Subject: Contract N62470-89-D-4814  
Navy CLEAN, District III  
Contract Task Order (CTO) 0267  
Response to USEPA, VDEQ and LANTDIV Comments  
Draft Work Plan for Site Screening Areas 2, 17, 18 and 19  
Naval Weapons Station Yorktown, Yorktown, Virginia

### **Response to Comments Submitted By USEPA Region III on the Draft Work Plan for The Site Screening Process at SSAs 2, 17, 18 and 19 Naval Weapons Station Yorktown**

Re: Naval Weapons Station, Yorktown, Va.  
Site- Screening Areas 2, 17, 18, and 19  
Review of draft *Work Plan*

Figure A-1

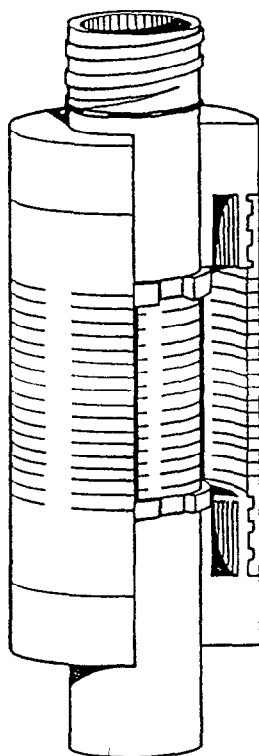
The use of a filter sock on the temporary piezometers should be evaluated and described in the report if it is going to be used.

8. Nylon mesh screen covers and/or the use of pre-constructed sand packs had been previously discussed for use with the temporary peizometers to aid in improving sample turbidity. Have these techniques been looked into in any greater detail?

9. The use of a TIMCO<sup>™</sup> Insta-Pack® is proposed for use with each hydropunch/temporary peizometer. The Insta-Pack® is a PVC screen -within -a- screen unit that is filled in the field with clean sand or gravel. A diagram of this unit is included as Figure A-1.

The major advantage of this device is that it is constructed of the same materials as standard monitoring wells and peizometers (PVC). This alleviates any concern regarding absorption and/or absorption of contaminants that could be raised by the use of a filter-sock or other similar commonly used filter fabrics.
  10. There are seven existing monitoring wells on site. The text will be revised to reflect that the seven wells will be sampled as part of this investigation.
  11. The text will reference Section 3.26 (Investigation Derived Wastes) of the Master Field Sampling Plan for WPNSTA Yorktown.
  12. The text will be corrected in response to this comment.

7. The SSA-19 boundries will be marked on Figure 4-4.
8. The use of a TIMCO<sup>™</sup> Insta-Pack® is proposed for use with each hydropunch/temporary peizometer. The Insta-Pack® is PVC screen-within-a-screen unit that is filled in the field with clean sand or gravel. A diagram of this unit is included as Figure A-1.

The major advantage of this device is that it is constructed of the same materials as standard monitoring wells and peizometers (PVC). This alleviates any concern regarding absorption and/or absorption of contaminants that could be raised by the use of a filter-sock or other similar commonly used filter fabrics.

The Insta-Pack®, however is more costly than the various filter fabrics. Baker estimates that use of the Insta-Pack® would add an additional \$100.00 to the cost of hydropunch/temporary peizometer installation. The filter fabrics are estimated to add less than \$10.00 additional to the cost of these installations.
